Figure A
Full-Rate Magnetic Response

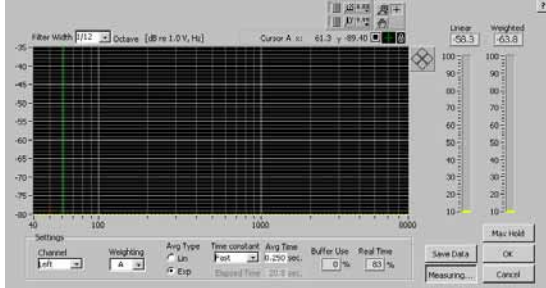
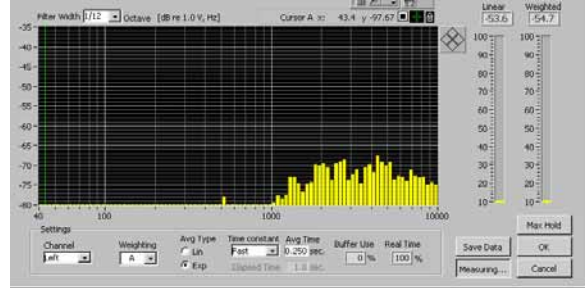
1) Please provide details of the device configuration and how 3G issues were accounted for to assure results were representative of typical usage.

This device was tested under the CDMA2000 configuration: Service Option 3, Radio Configuration 1. Under this radio configuration, 1/8 rate gating is exhibited while the microphone MUTE=ON. This generates a worst-case condition for T-coil measurements due to the gating noise, as compared to a full-rate mode that does not exhibit gating noise (see below).

Frequency Response Characterization

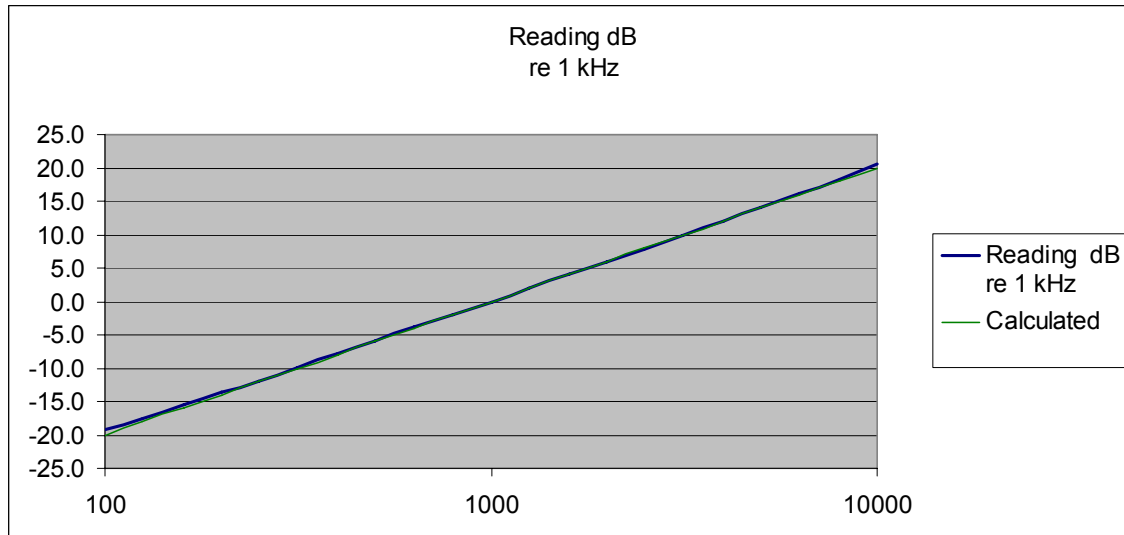
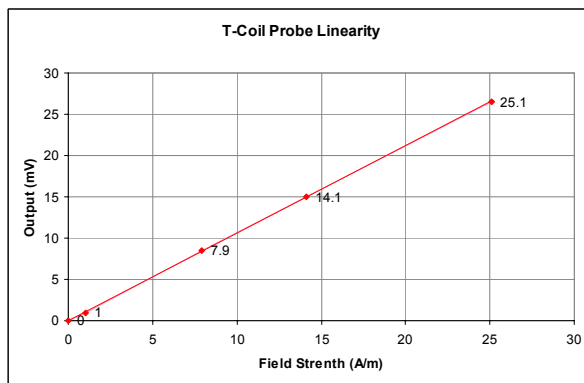
6) Please include a demonstration that the probe/system complies with the frequency and linearity response requirements in C63.19 Annex C.5.

Please see below for frequency and linearity response tests of the probe/system:

Figure E
ABM2 Spectrum Plot

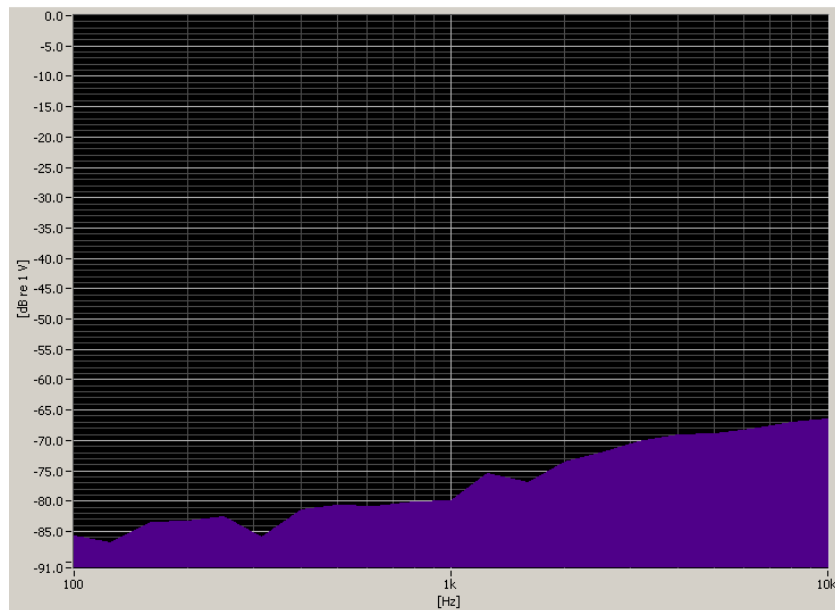
13) Please explain the use of 5 second measurement time for ABM2 in II4ci. Please provide a spectral plot.

Five seconds for the noise measurement was used as a standard noise measurement time interval for acoustic noise tests (i.e. IEEE 269, etc.).

Please see below for the ABM2 spectral plot:
